JRC questions to SIGTP-02-11

2nd SIG TP meeting, Jan 30, 31 and Feb 01, 2024

Slide 4 of SIGTP-02-11

Figure 3
Flow-chart for the verification of thermal propagation safety compliance

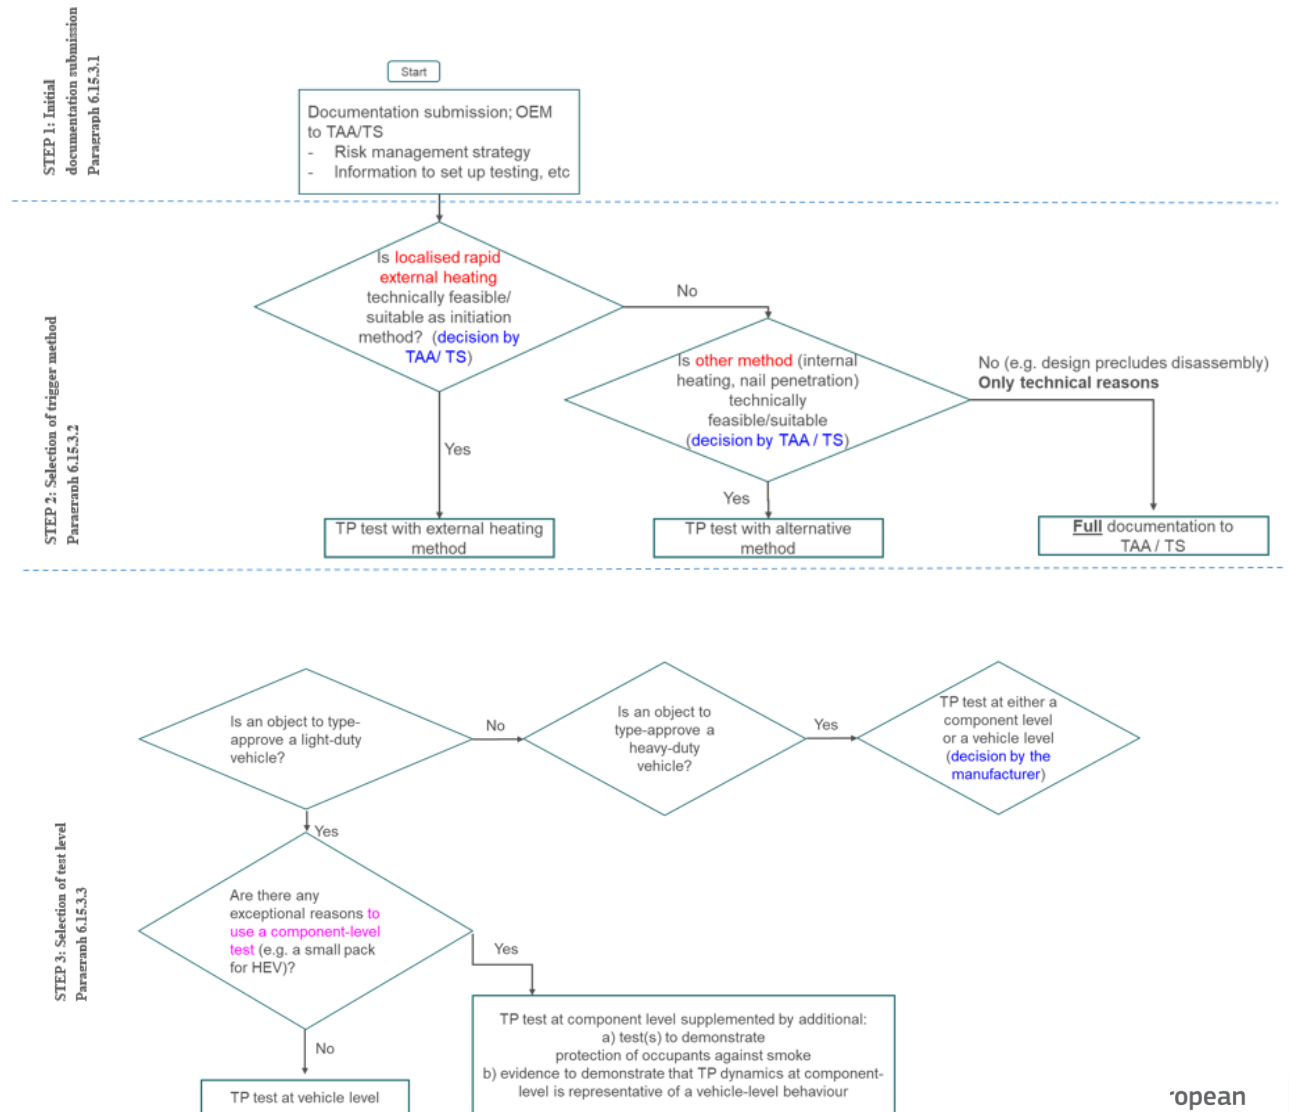
- The flow chart for the verification of thermal propagation safety compliance has been agreed among CN, EU and JP supported by KR and industry at 27th GTR EVS meeting and further refined at the 1st SIG TP meeting.
- For light duty vehicles, vehicle-level test is a default method.
